Re: Bergamot Transit Village Draft Environmental Impact Report

The Santa Monica Coalition for a Livable City (SMCLC) submits the following comments on the Draft Environmental Impact Report (DEIR) for the Bergamot Transit Village, through the law firm of Strumwasser & Woocher LLP. SMCLC is a nonprofit, entirely volunteer group of Santa Monica residents concerned about unsustainable commercial development in the City and its effects on traffic and quality of life. SMCLC has serious concerns regarding the size of the proposed project — which appears to be one of the largest in Santa Monica's history — and its significant, negative impacts in an already gridlocked area, the cumulative effect of the proposed project and the numerous other large projects already under consideration or in development for the area around the proposed project, and the failure of the DEIR to adequately assess the proposed project's conformity with the currently-in-progress Bergamot Area Plan for the 140 acres surrounding and including the proposed project's seven-acre site, or in light of a regional plan that addresses appropriate development in the City of Santa Monica and nearby areas of Los Angeles.

EXHIBIT 2

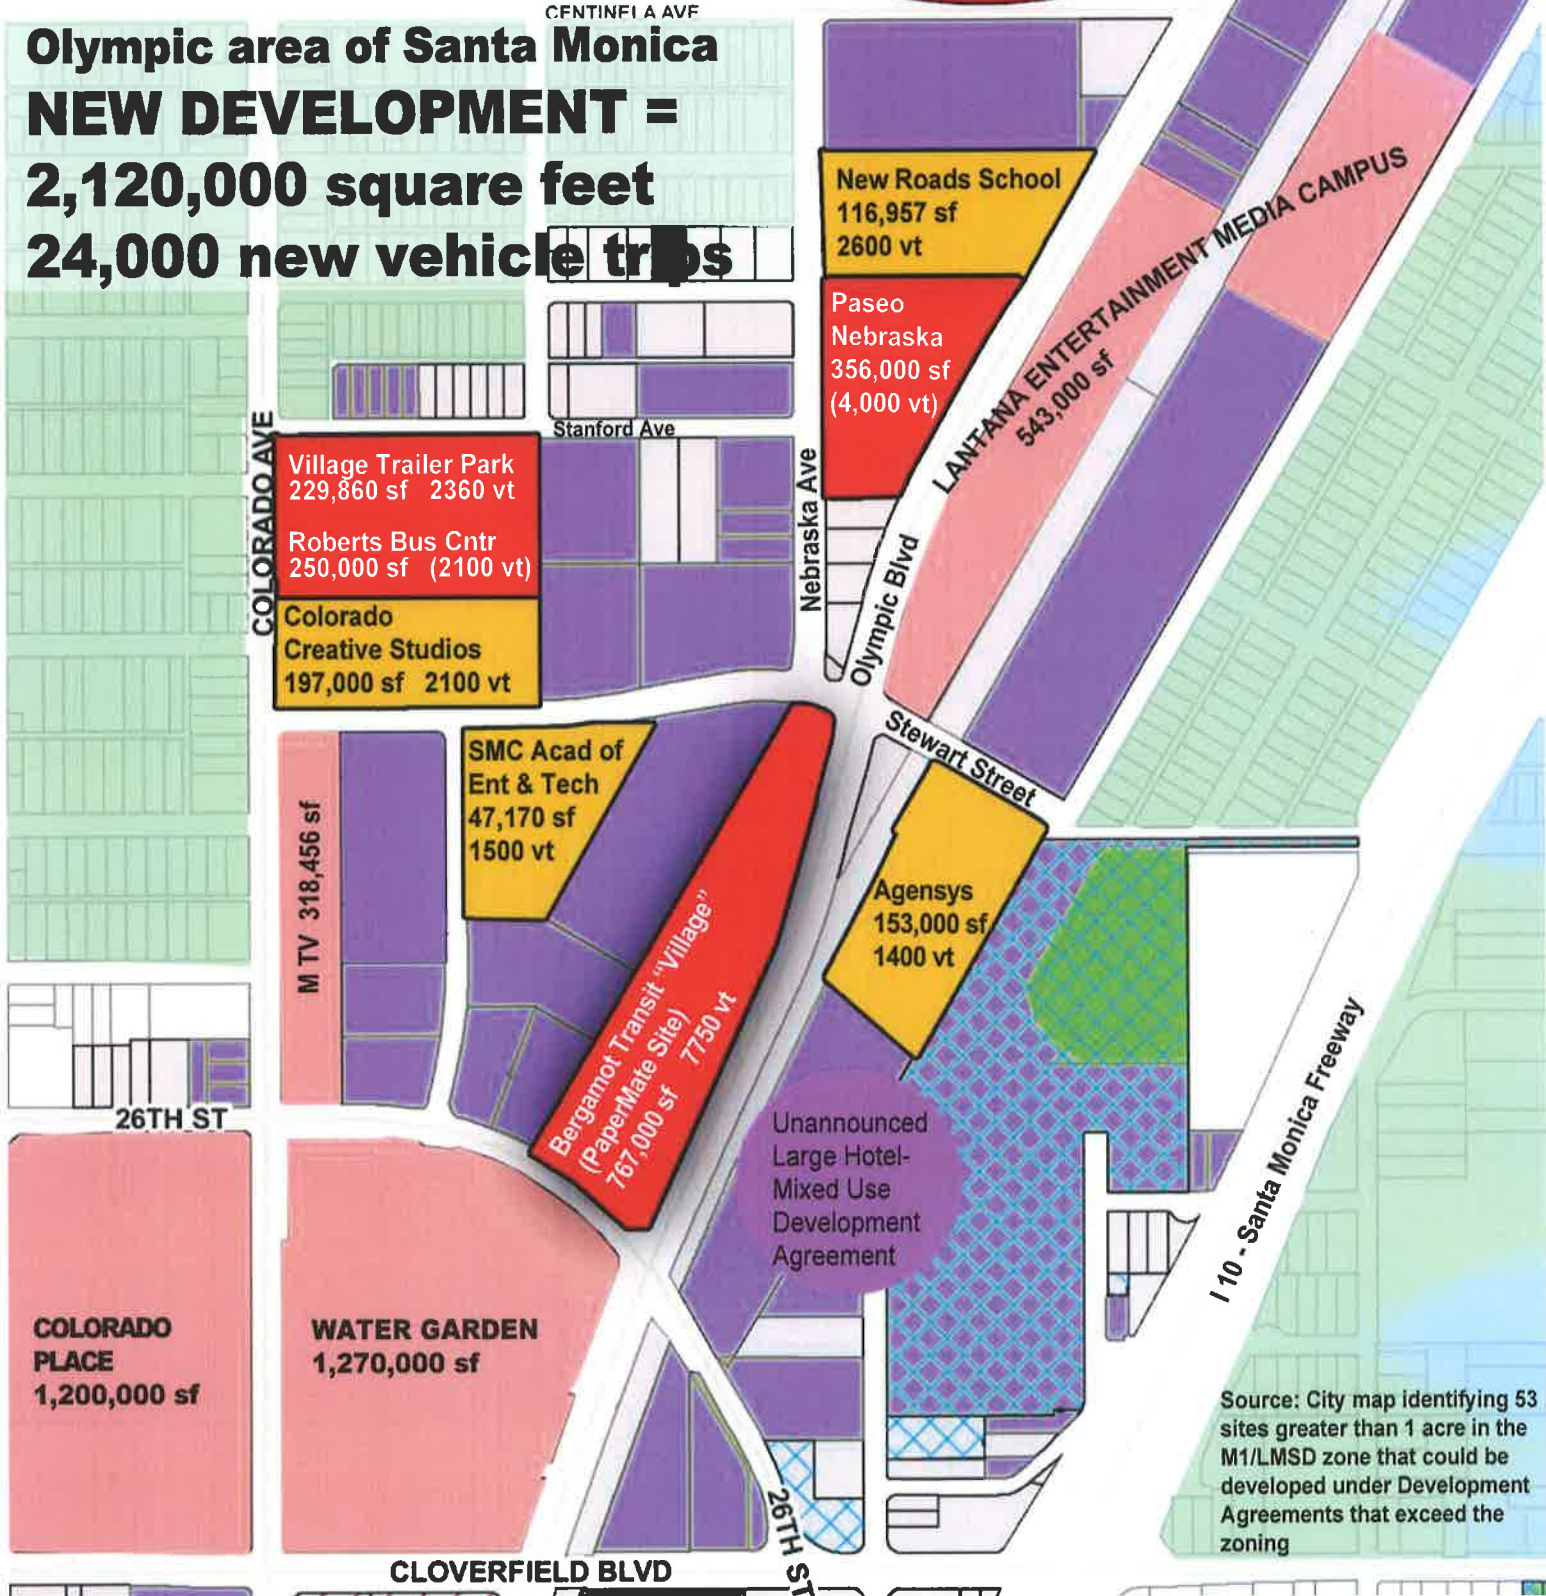
The DEIR does not appear to fully take into account the impact of an additional 24,000 trips in this area, or region-wide. According to the DEIR, this project and all of the related projects will have impacts on traffic and the transportation grid over a wide-ranging area, including as far away as Montana Avenue and Barrington Avenue to the north, and Centinela Avenue and Venice Boulevard to the south. Of the 97 intersections evaluated in the DEIR’s traffic study, 25 are forecasted to be significantly impacted by traffic from the proposed project under current (year 2012) conditions. The map of impacted intersections — conspicuously absent from the DEIR — shows impacts far to the north and south of the project site. (See Exh. 2.)
